LOCATION Hwy 401, 1 km E of
Culloden Rd. - Slope Failure

RE: Review of Contract Drawings and Documents
Highway 401 at Whiting Creek
W.P. 374-94-00
District #31, London/Stratford

Re: Embankment Slope Failure
Highway 401 at Whiting Creek
East of Culloden Road
W.O. 94-11009 (Cont. 92-06, W.P. 374-94-00)
District 2, London

Re: Embankment Slope Failure
Highway 401, 1 km East of Culloden Road
W.O. 94-11009 (Cont. No. 92-06, W.P. 479-89-00)
Geocres 40P2-54
District 2, London

MID HEIGHT SAFETY BERM DESIGN

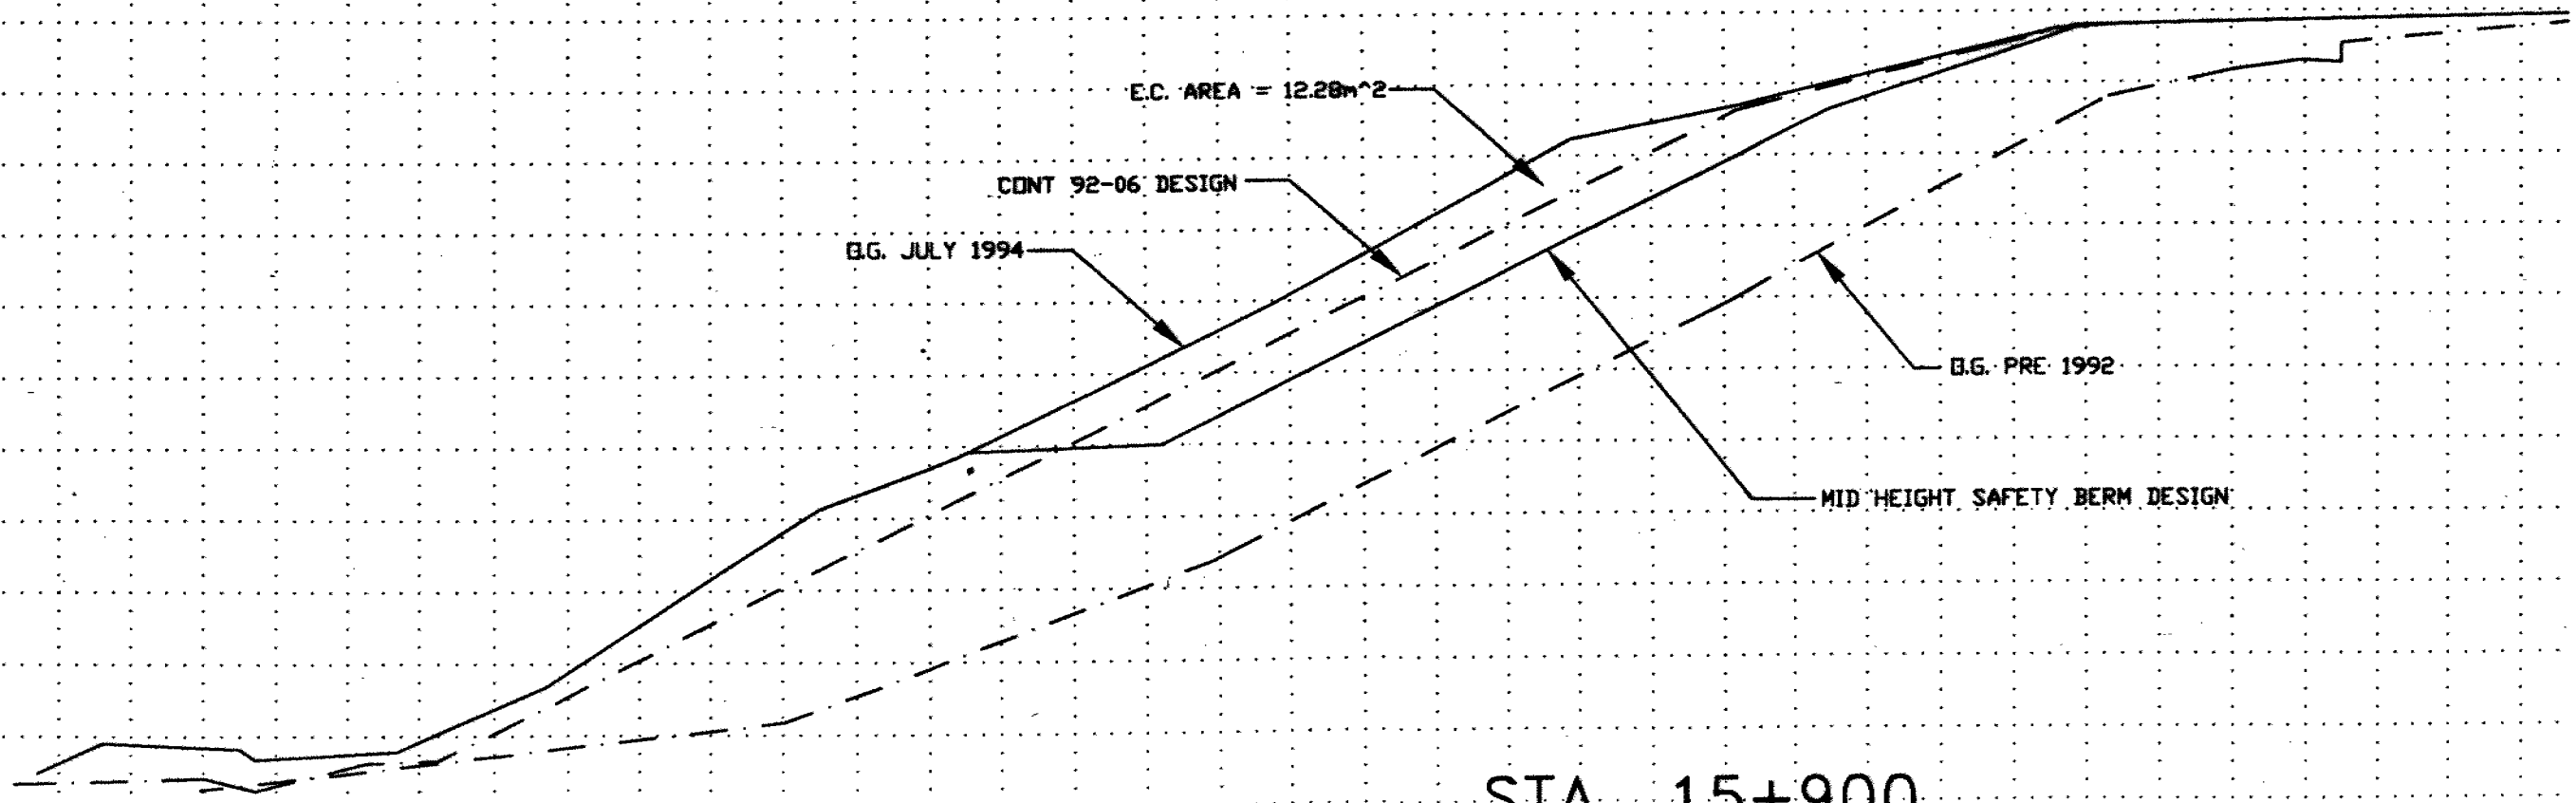
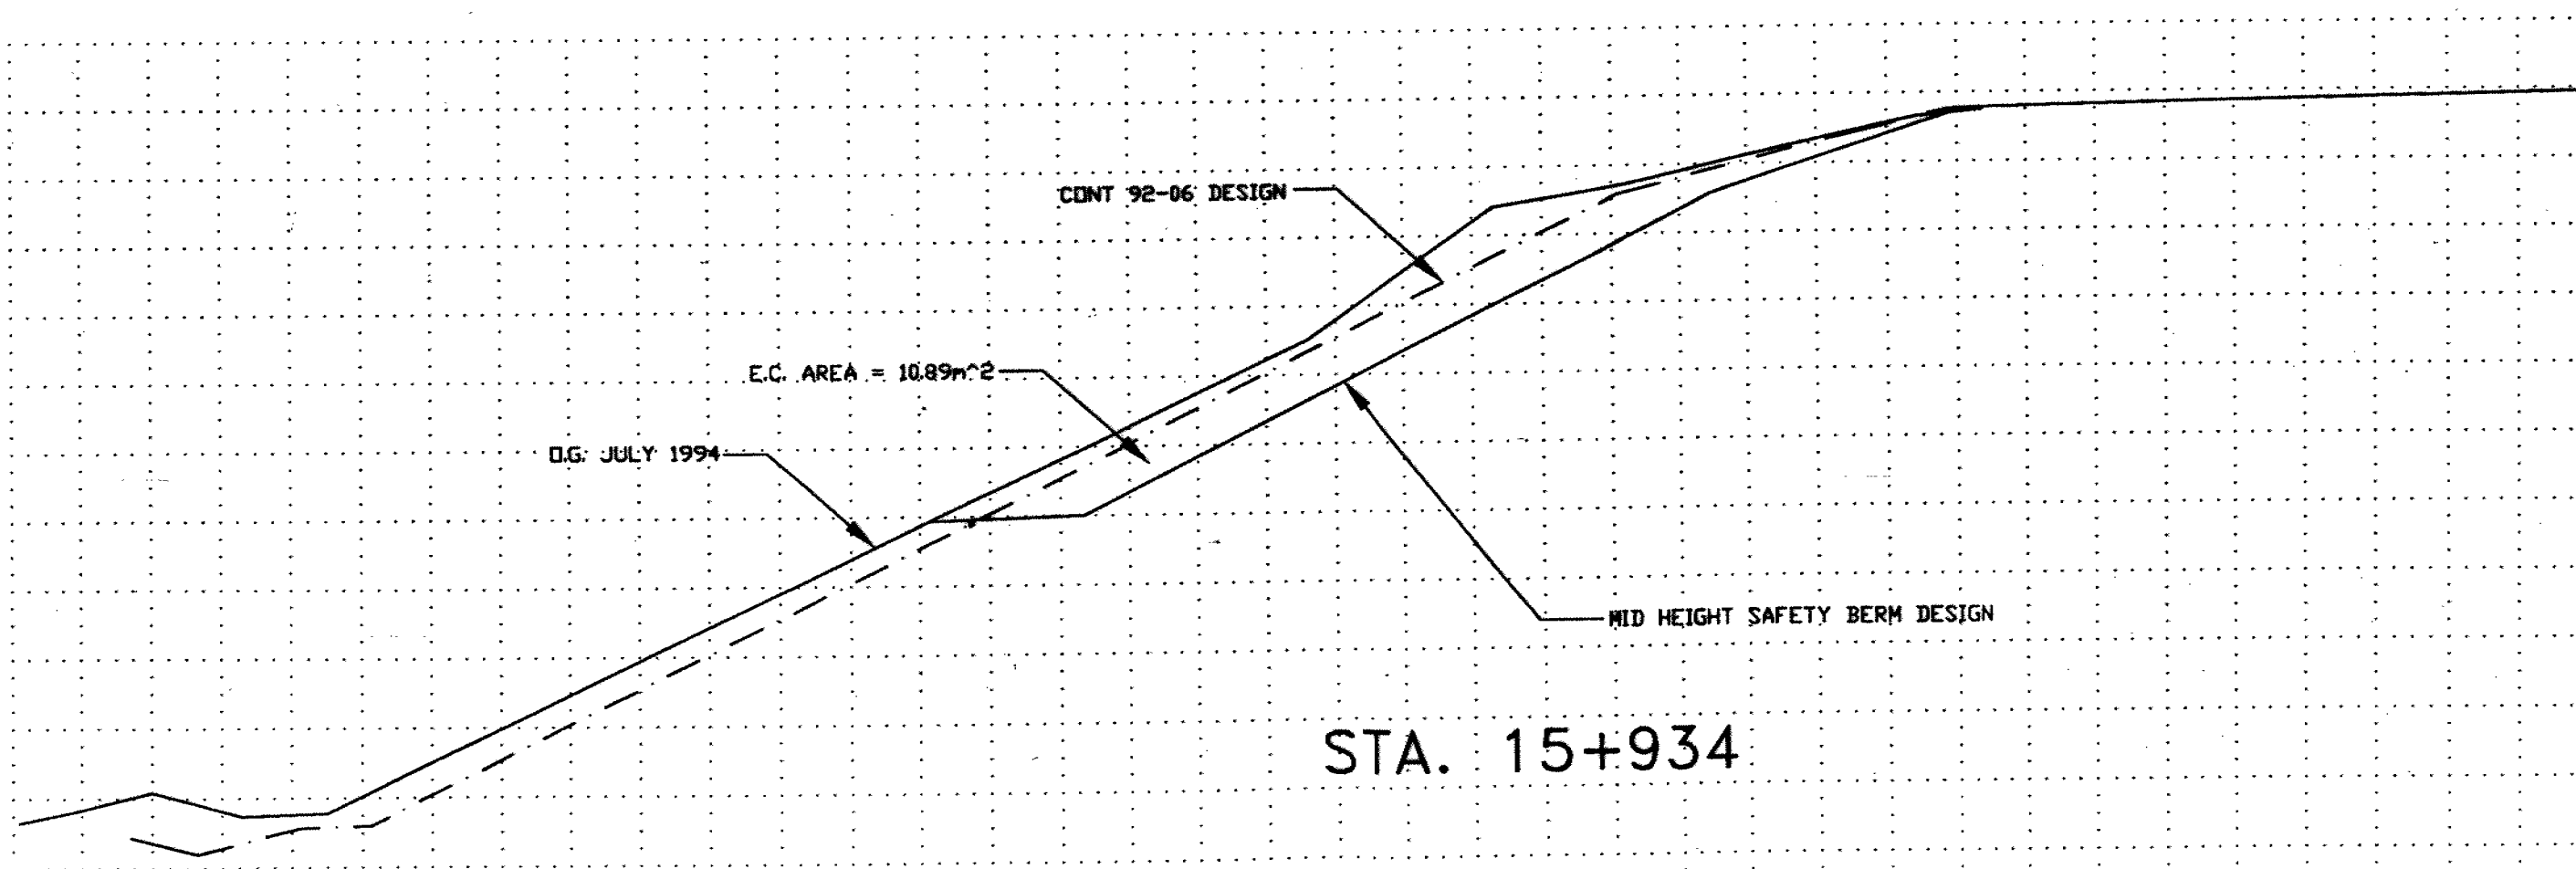
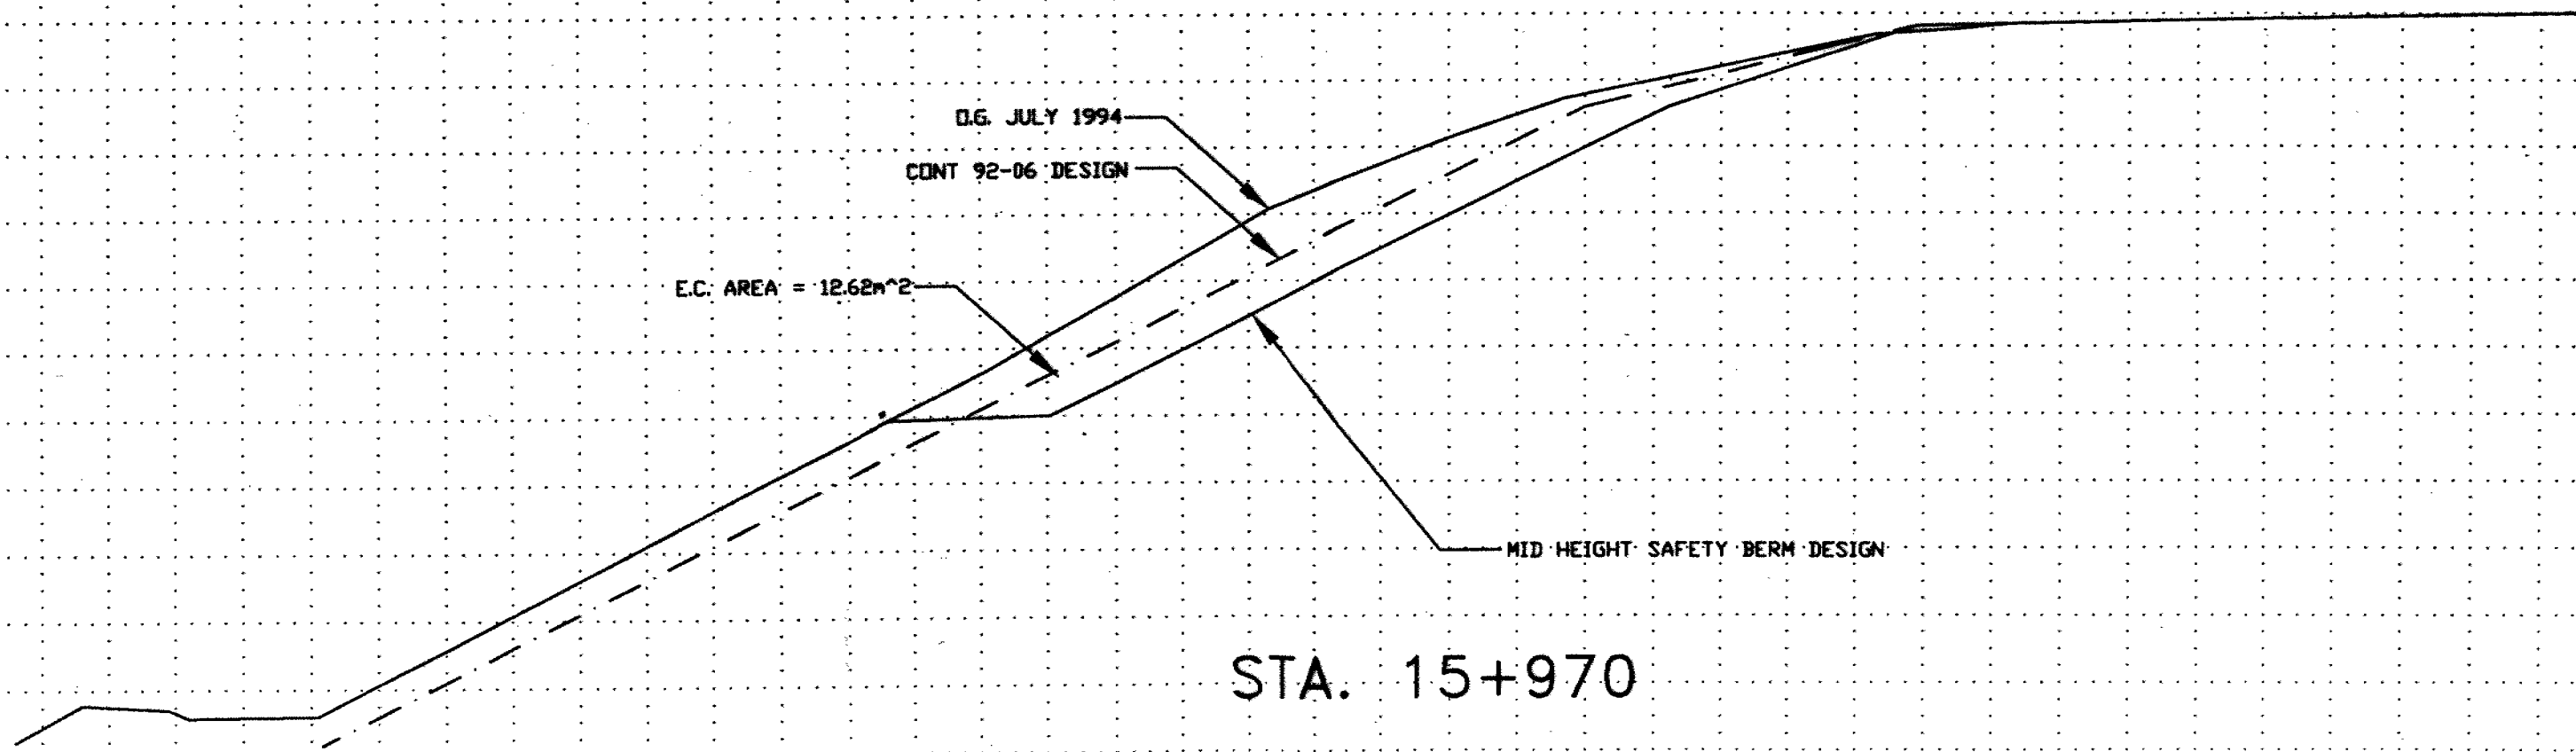
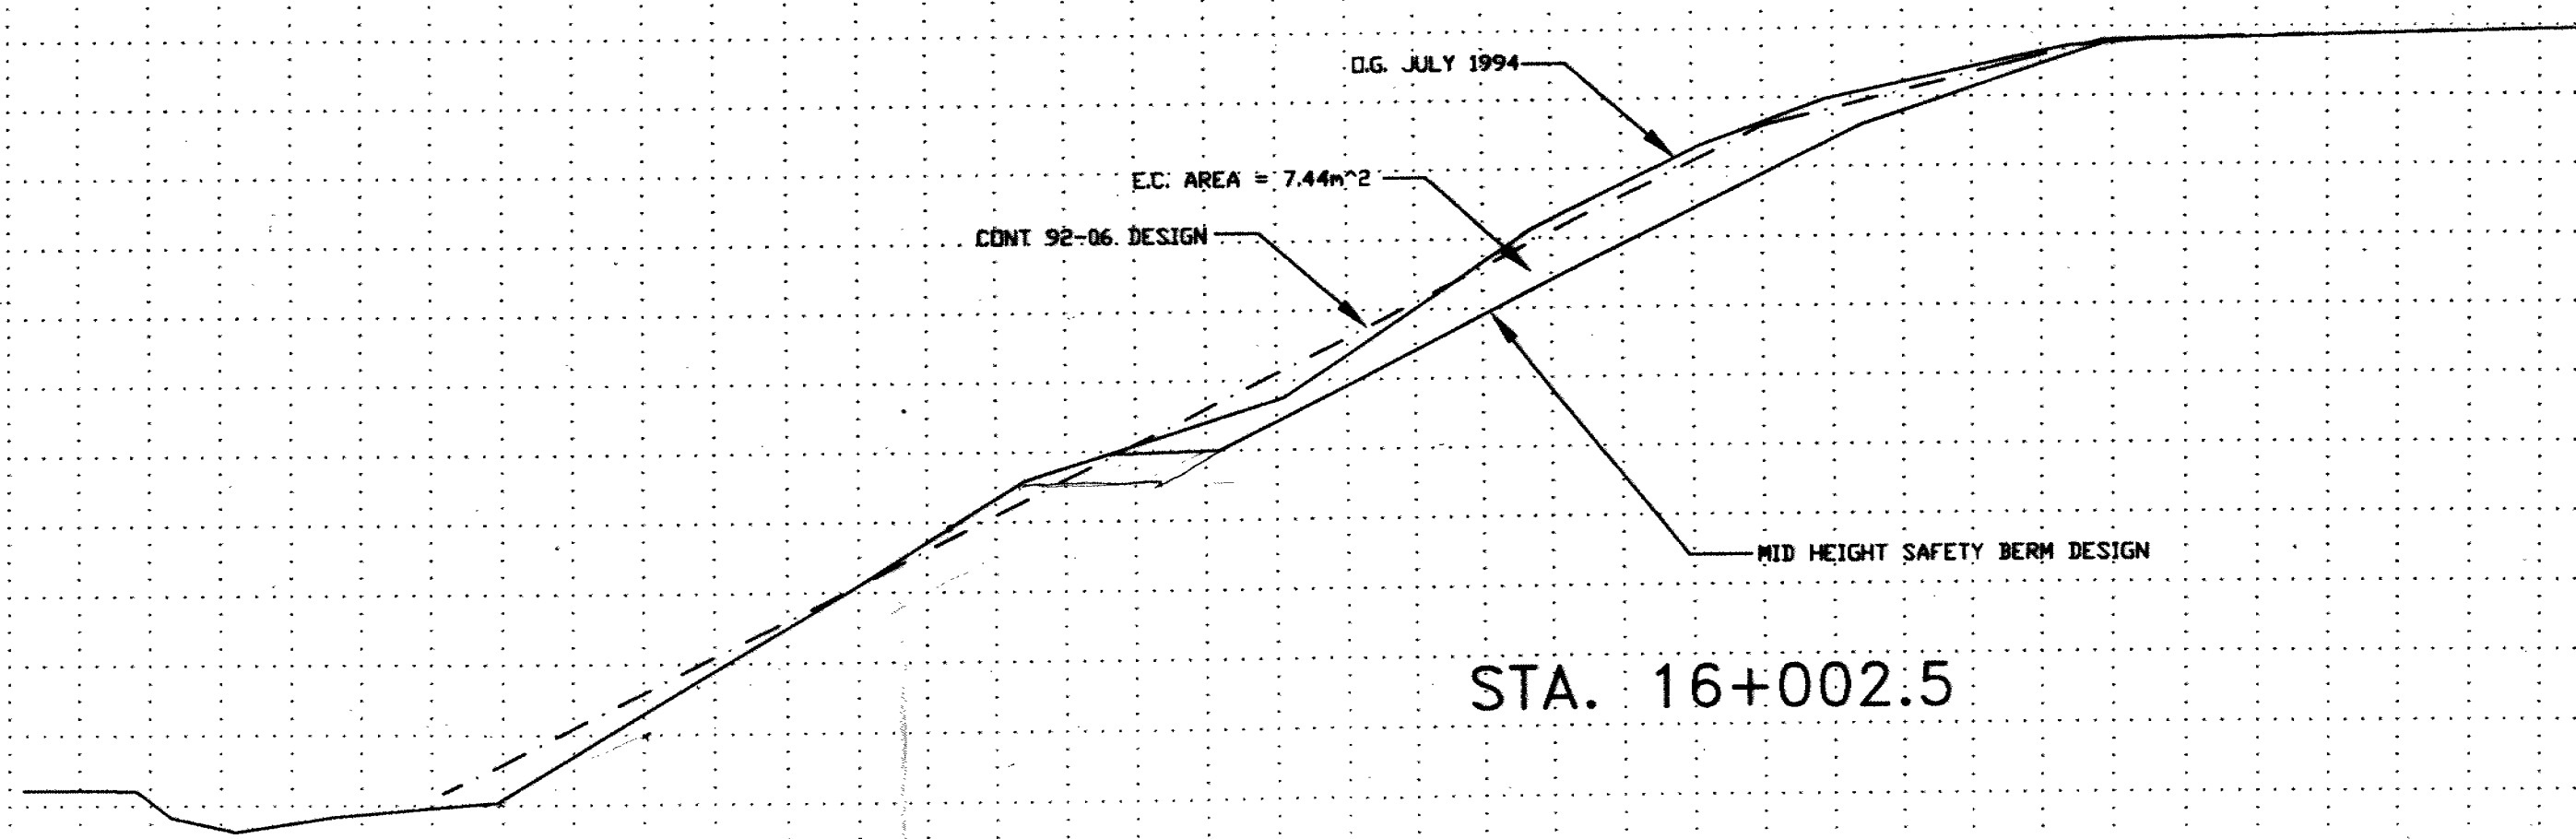
As you are aware, proposed remedial work to these slopes has been delayed until the summer of 1995. The attached cross-sections were surveyed in July 1994 and show the following information.

- Original ground prior to Contract 92-06
- Theoretical widening on the north side of Highway 401 from Contract 92-06 design section rolls
- Ground as determined in July 1994
- Proposed mid height berm design based on maintaining the existing 1.0 m rounding, steepening up the granular side slope behind the guide rail from 4:1 to 3:1, removing the earth fill below the new G/R point at a 2:1 slope, and constructing a safety (mid height) berm at elevation 285.00 m to intersect the original ground

Cross-sections at Sta 15+900, 15+934, 15+970 and 16+025 show material in excess of the Contract 92-06 design line. Towards the end of construction in 1993, surficial failures occurred on both north and south slopes and equipment was used to pull excess material back up the slope. In many cases the G/R point was covered with earth preventing positive seepage from the granular base.

Recommendations presented in your memo dated August 26, 1994 have been discussed on several occasions including representation from Planning and Design, Construction, District and Geotechnical. Based on these discussions, we have the following questions and suggestions for your consideration (recommended remedial measures listed on page 2 of your memo are addressed in numerical order):

- OK
- (1) In order to avoid widening the lower half of the slope, relocation of the ditch and possible purchase of property, we recommend that the lower half of the slope with the exception of trimming and compacting remain as it is. The detail on the cross-section indicates this can be achieved by maintaining the existing 1.0 m rounding, steepening up the granular side slope behind the guide rail from 4:1 to 3:1, removing the earth fill below the new G/R point at 2:1 slope, and constructing a safety berm at about elevation 285.00 m to intersect the original ground. This will mean that the mid height berm will vary in width from 1.6 to 2.8 m, whereas the width recommended in your memo is 2.0 m. OK.

We suggest that a ditch be constructed along the mid-height berm to intercept the runoff water identified in your point 3, therefore eliminating the need for the cutoff trench and subdrain. The ditch would have a longitudinal slope which would outlet to rip-rap lined chutes. Planning and Design proposes to carry out a drainage design to size this mid height ditch and determine whether rip-rap is necessary.

Still need to depress ground water level

still need subdrain
